**Application of Cameron Grogan c/o BF Austin, LLC to rezone properties from R-75 (Residential Medium Lot-75) zoning district to RSM (Small Lot Residential Mix) zoning district to allow for the development of a new, 62-unit, single-family attached development, at 1491, 1531 and 1555 Austin Drive.**

**PETITION NO: N8-2024-1109 Z-24-1247190**

## STAFF ANALYSIS

<b>Case No.:</b>	Z-24-1247190	<b>Agenda #:</b> 2024-1109
<b>Location/Address:</b>	1491, 1531, and 1555 Austin Drive in Decatur, Georgia.	<b>Commission District:</b> 3 <b>Super District:</b> 7
<b>Parcel ID:</b>	15-197-02-10, 11, & 33	
<b>Request:</b>	To rezone properties from R-75 (Residential Medium Lot District-75) to RSM (Residential Small Lot Mix) district to allow the construction of a single-family attached development.	
<b>Property Owner:</b>	BF Austin LLC	
<b>Applicant/Agent:</b>	Cameron Grogan	
<b>Acreage:</b>	7.8 acres	
<b>Existing Land Use:</b>	Vacant land and vacant single-family structures	
<b>Surrounding Properties:</b>	Institutional (Towers High School), Single-Family Residential, Commercial (Self Storage Warehouse), and Townhomes.	
<b>Adjacent Zoning:</b>	North: R-75 South: R-75 East: OD, C-1, MRD West: R-75

## REZONING SITE PLAN

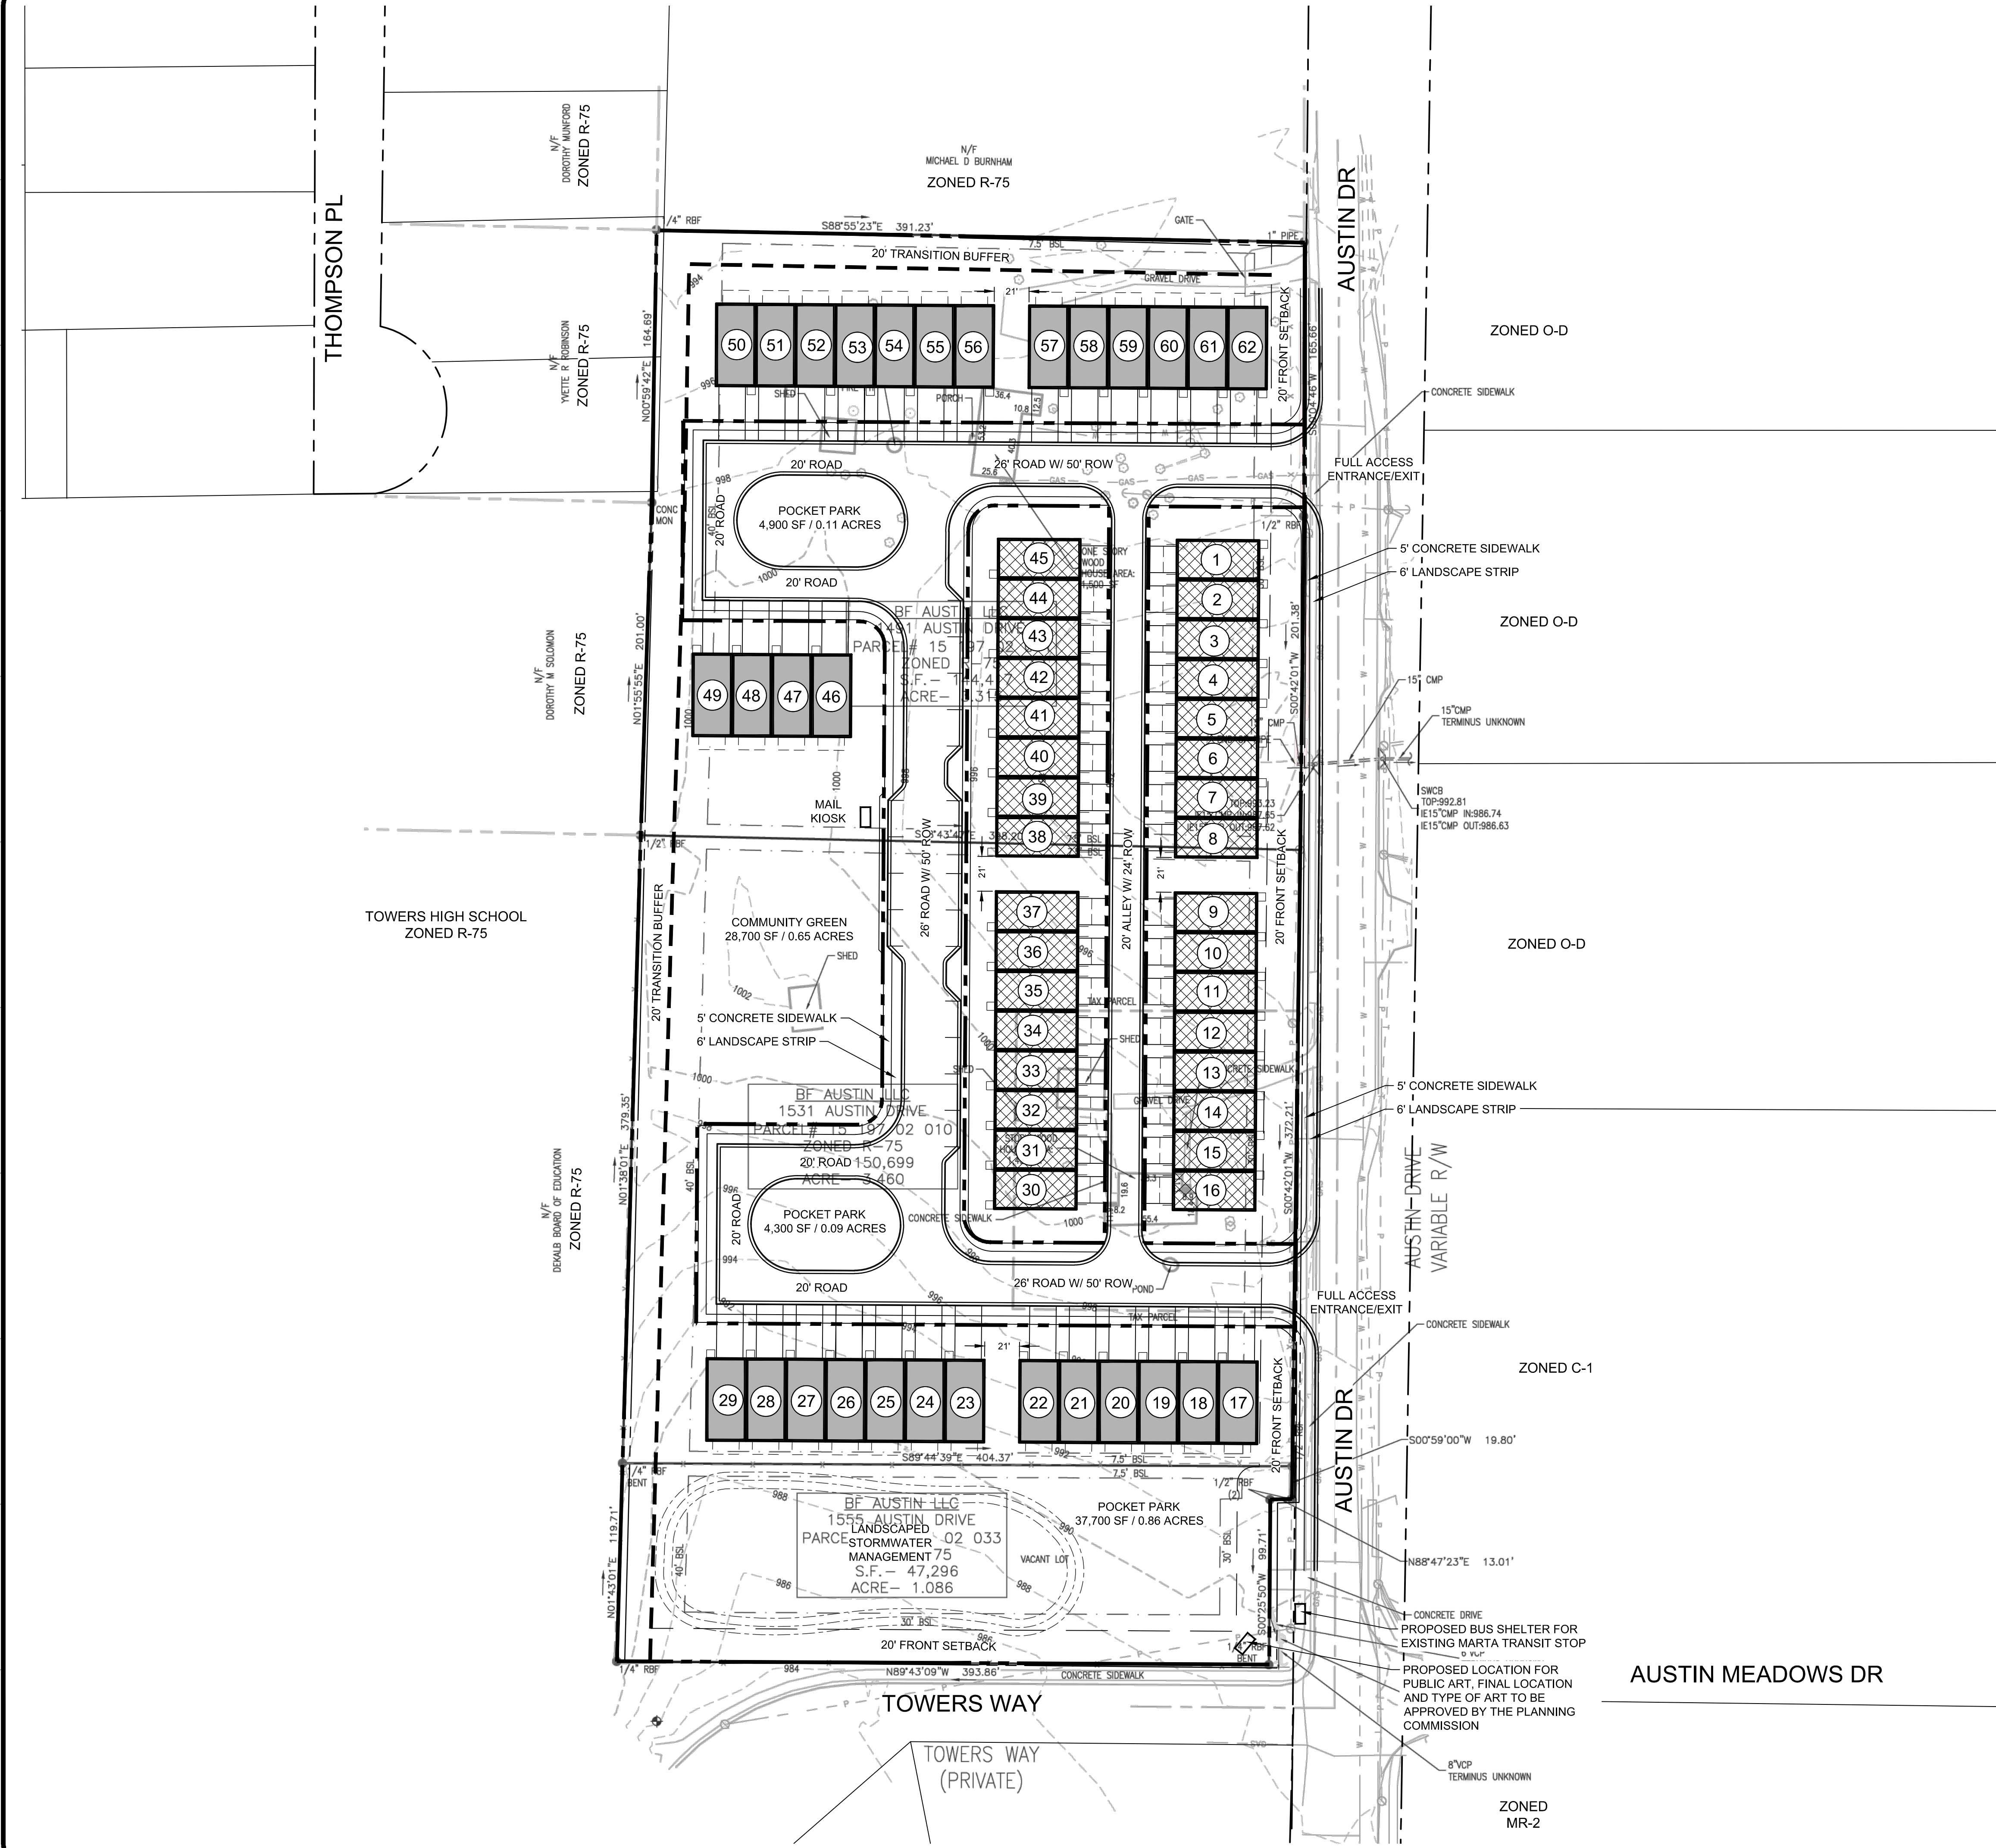
Consult the DeKalb County Transportation Department prior to land development permit. Verify widths from the centerline of the roadways to the property line for possible right-of-way dedication. Improvements within the right-of-way may be required as a condition for land development application review approval. Safe pedestrian and vehicular circulation are required compliant with DeKalb street standards. Paved off-street parking is required. Functional sidewalks, unobstructed by vehicles in driveways, are not clear in the site plan.

Compliance with the Georgia Stormwater Management Manual, DeKalb County Code of Ordinances 14-40 for Stormwater Management and Water Quality Control is required as a condition of land development permit approval. Show how runoff reduction and water quality treatment will be provided. There is a ridgeline through the development with drainage to both Snapfinger Creek as well as Cobbs Creek. Stormwater management under the private roadway is not recommended as system failures may restrict access to residences.

State water buffer was not reflected in the G.I.S. records for the site and is noted in the plan. Typical state waters buffer requires a 75' undisturbed stream buffer and land development within the undisturbed creek buffer is prohibited without a variance per DeKalb County Code of Ordinances 14-44.1.
